Request for Quotation

DEFK12000

LINE	QUANTITY	UOP	CAT. NO.	ITEM NUMBER	UNIT PRICE	AMOUNT
ADDENDUM NO. 2						
1. QUESTIONS AND ANSWERS ARE ATTACHED. 2. REVISED BID FORM ATTACHED. 3. ADDENDUM ACKNOWLEDGEMENT IS ATTACHED. THIS DOCUMENT SHOULD BE SIGNED AND RETURNED WITH YOUR BID. FAILURE TO SIGN AND RETURN MAY RESULT IN DISQUALIFICATION OF YOUR BID.						
EXHIBIT 10						
REQUISITION NO.: DEFK12000						
ADDENDUM ACKNOWLEDGEMENT						
I HEREBY ACKNOWLEDGE RECEIPT OF THE FOLLOWING CHECKED ADDENDUM(S) AND HAVE MADE THE NECESSARY REVISIONS TO MY PROPOSAL, PLANS AND/OR SPECIFICATION, ETC.						
ADDENDUM NO.'S:						
NO. 1						
NO. 2						
NO. 3						
NO. 4						
NO. 5						
I UNDERSTAND THAT FAILURE TO CONFIRM THE RECEIPT OF

NEW FACILITIES FOR THE
MOOREFIELD READINESS CENTER
MOOREFIELD, WEST VIRGINIA
CONSTRUCTION & FACILITIES MANAGEMENT OFFICE
WEST VIRGINIA ARMY NATIONAL GUARD

ADDED STORMWATER STRUCTURE SCHEDULE

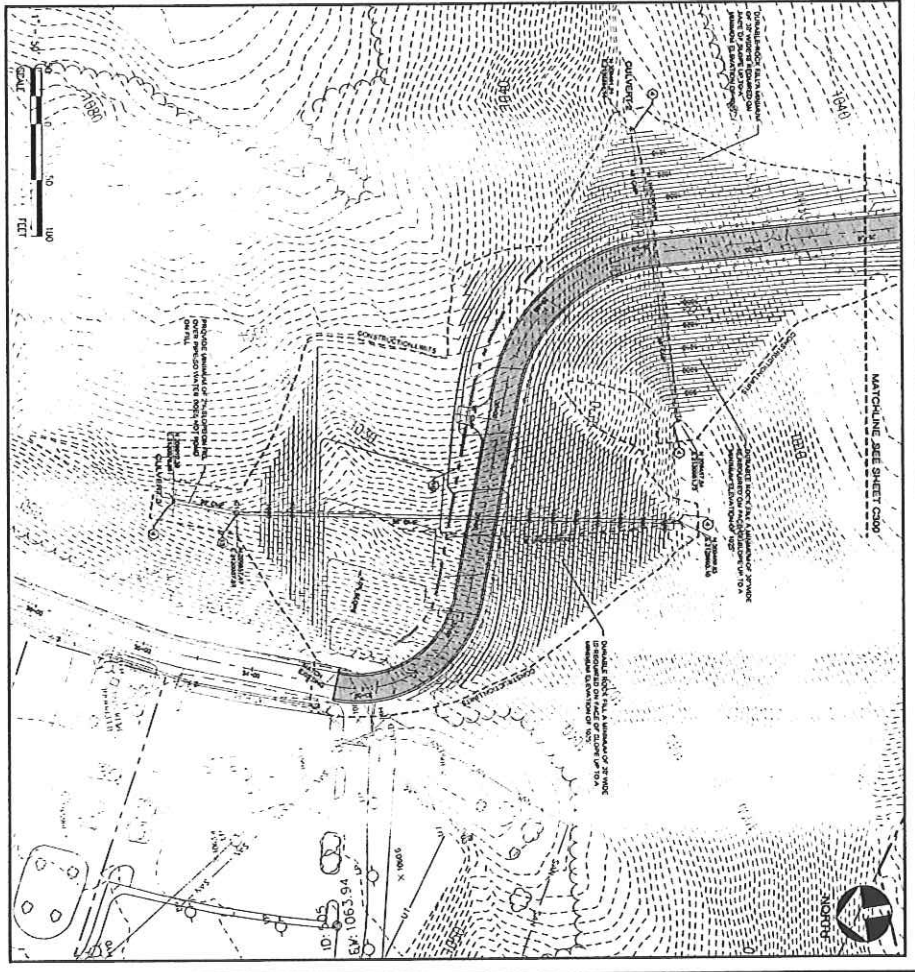
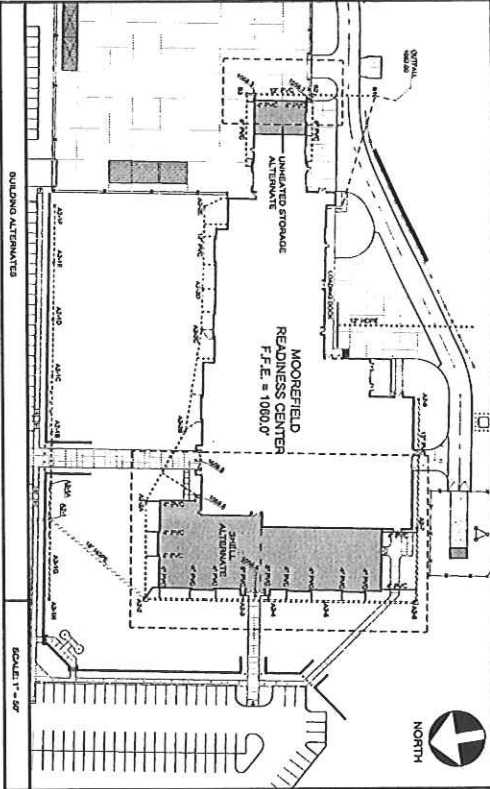
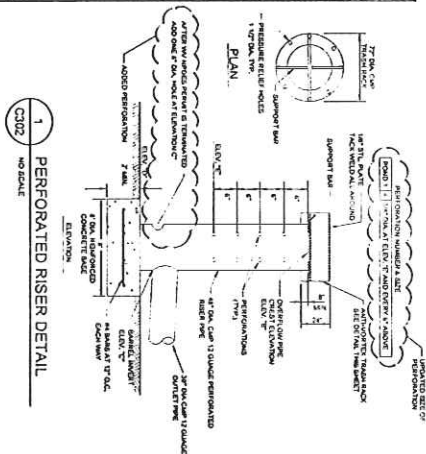
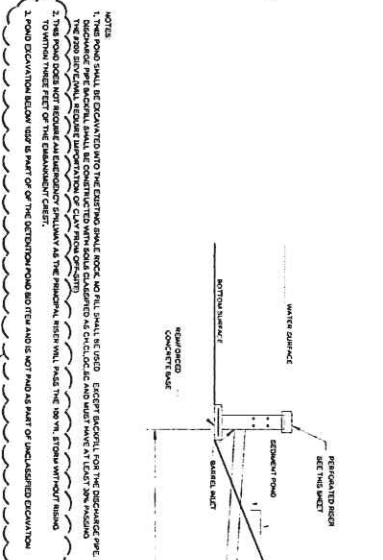
C300 – Grading and Drainage
 C301 – Grading and Drainage Continued
 C302 – Pond Plan
 C600 – Typical Pavement Sections
 C601 – Typical Pavement Sections
 C602 – Typical Pavement Sections
 C700 – Storm Profiles
 C801 – Paving Details

DWG. NO:
SKM-1

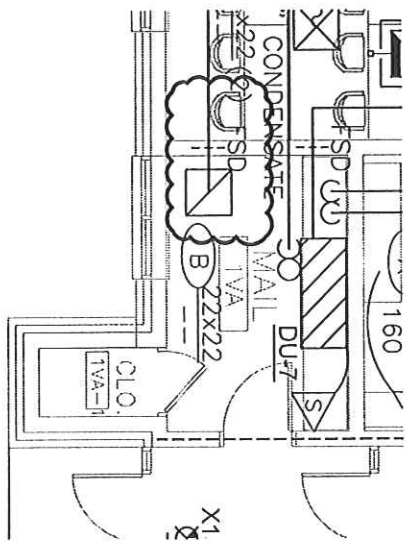
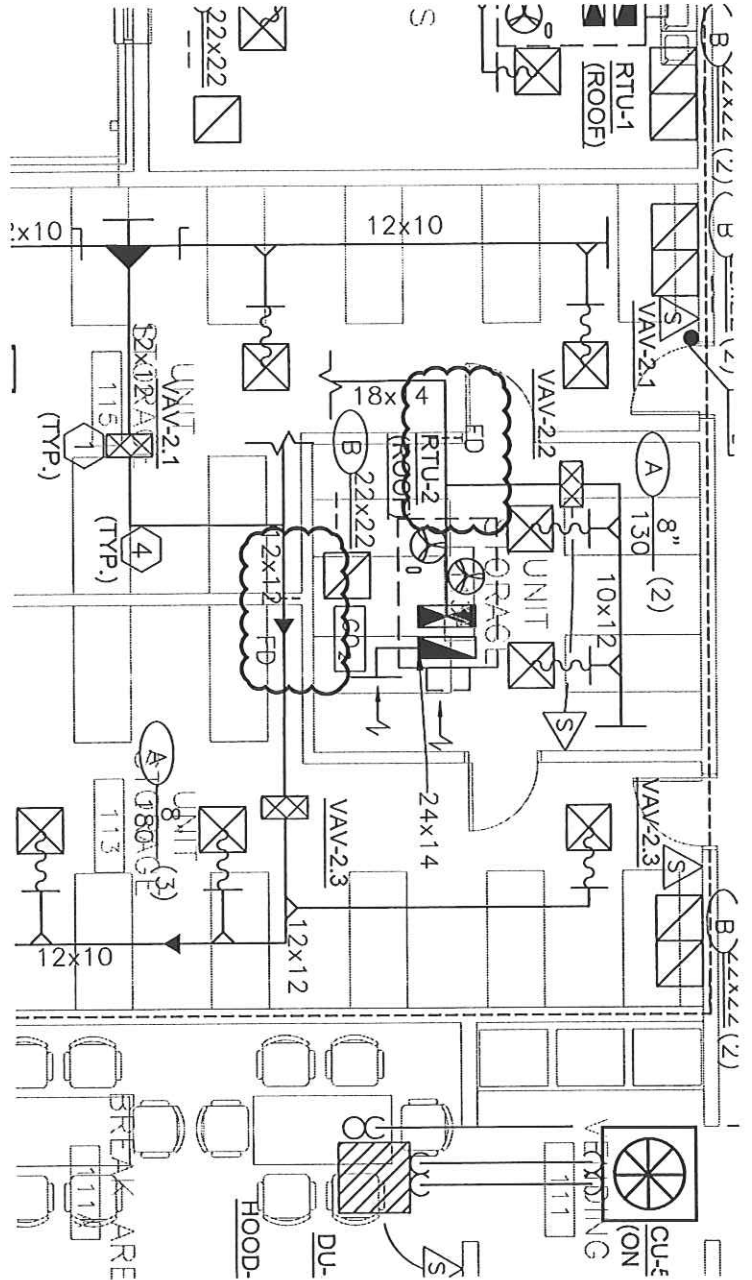
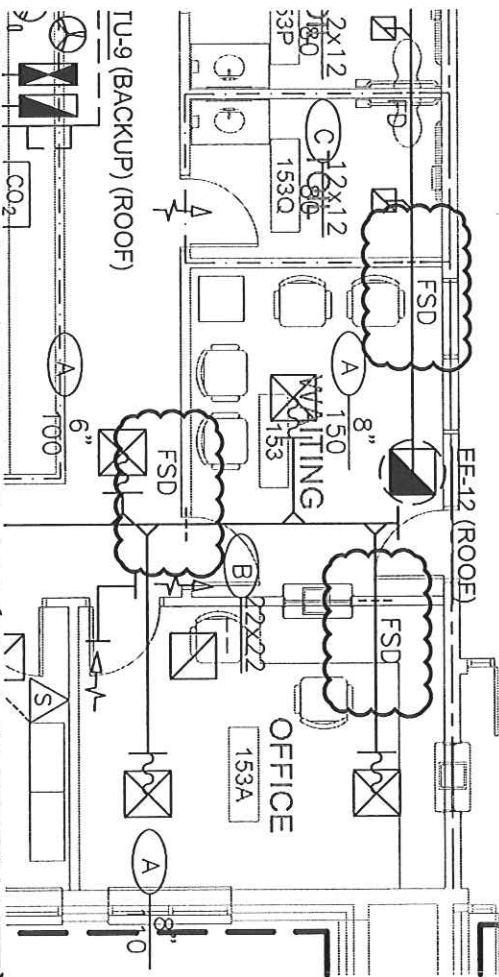
Item #12 Drawings M101 and M103 – HVAC Floor Plan 'A' and 'C'

A. Add fire / smoke dampers per attached Sketch SKM-1.

PARTIAL FLOOR PLAN - AREA "B"

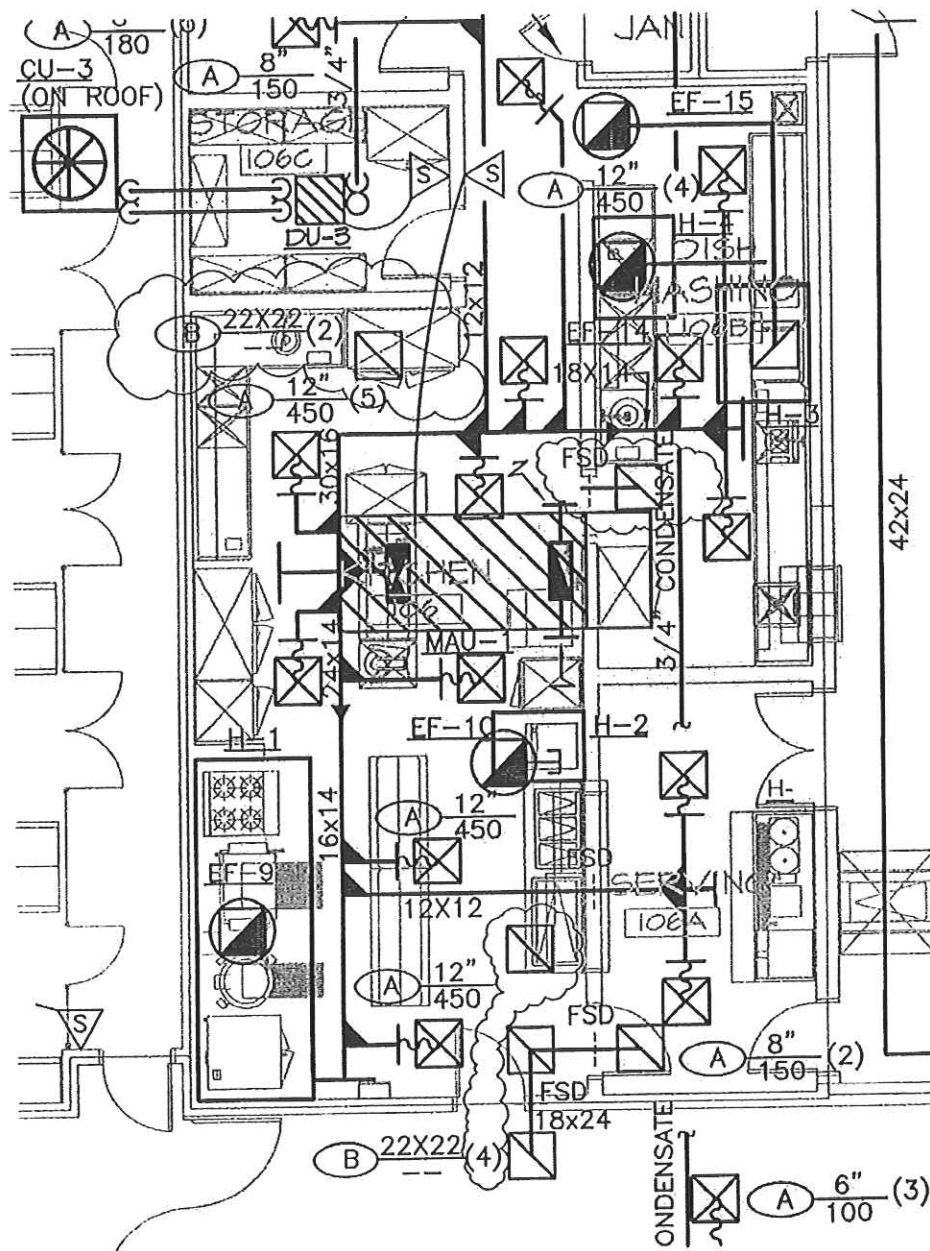
Item #13 Drawing M-102 – HVAC Floor Plan 'B'

A. Add return grilles in Kitchen and Dishwasher Room per Sketch SKM-2.
